**ADDENDUM #1**

**TO CONTRACT DOCUMENTS FOR:** Project #CP230811 – IDEXX - Replace Chillers

**PREPARED FOR:** The Curators of the University of Missouri

DELIVERY AND STAGING LOCATION

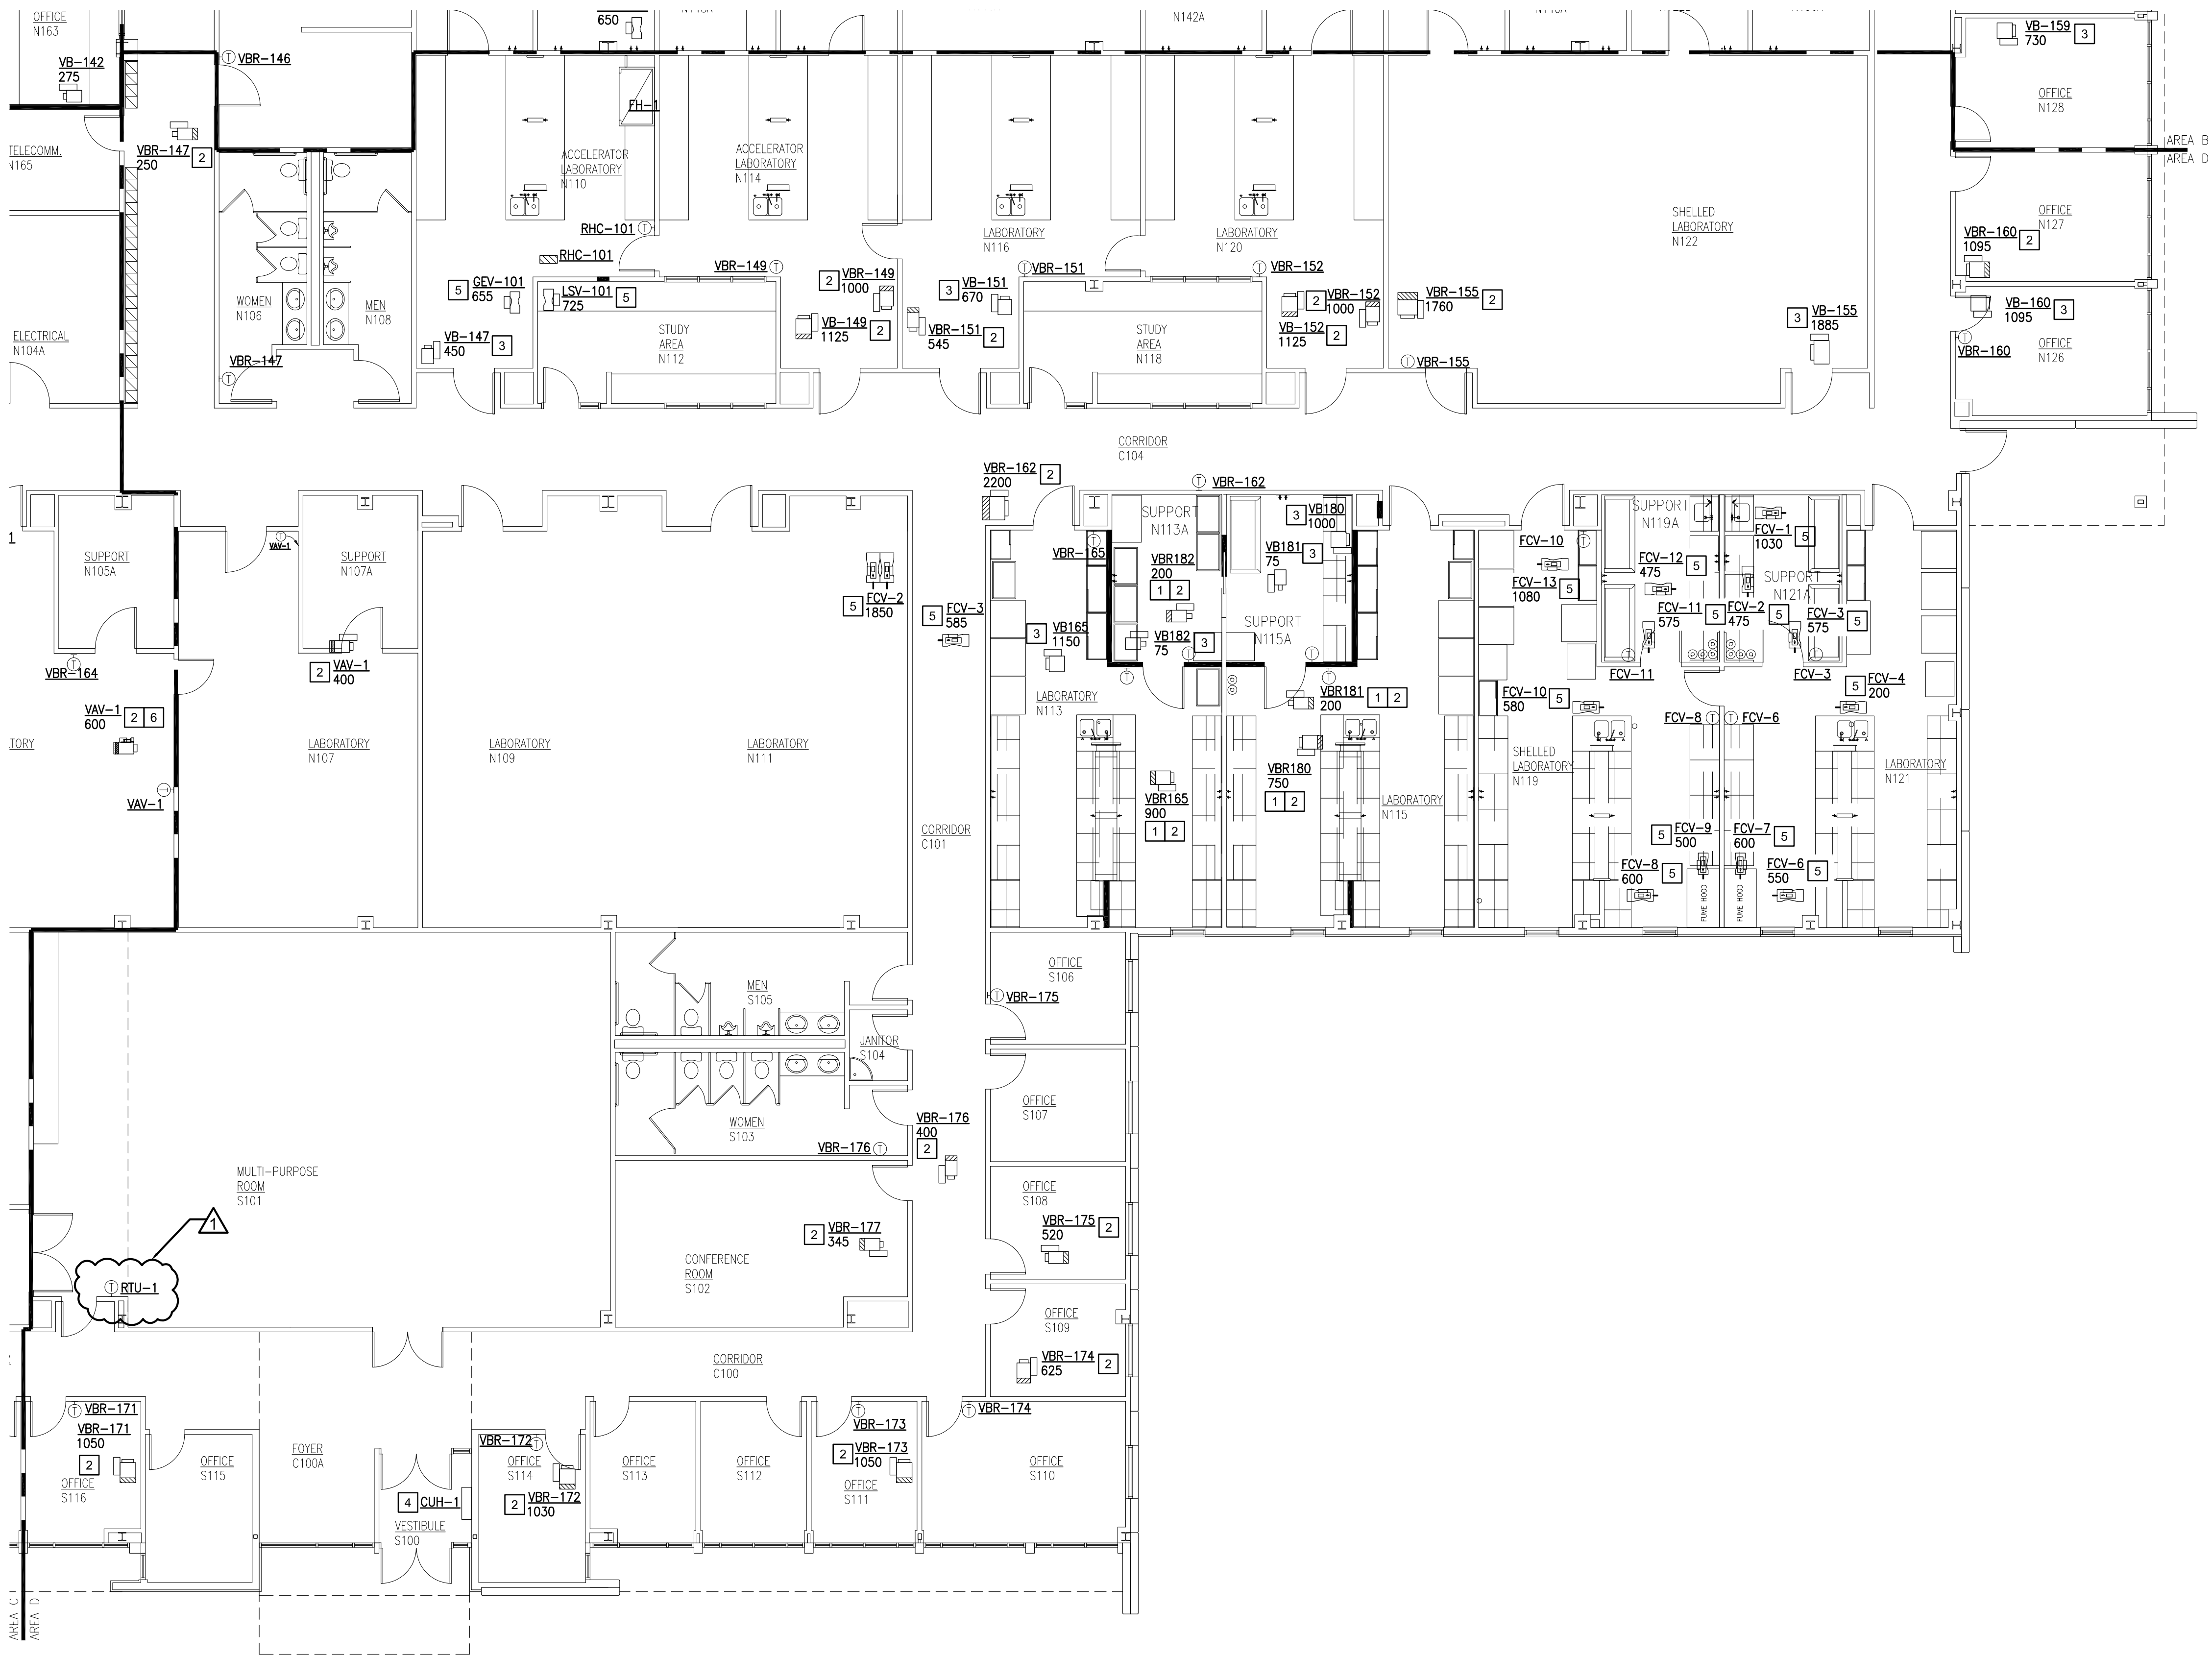
- 1) M000: Reference attached drawing.
  1. Added general note clarifying ceiling work requirements.
  2. Revised “Delivery and Staging Location” plan to indicate clearances required around existing fire hydrant for delivery and staging of new chillers.
- 2) M304: Reference attached drawing. Added location of existing thermostat associated with RTU-1.
- 3) M400: Reference attached drawing. Added section through exterior wall.
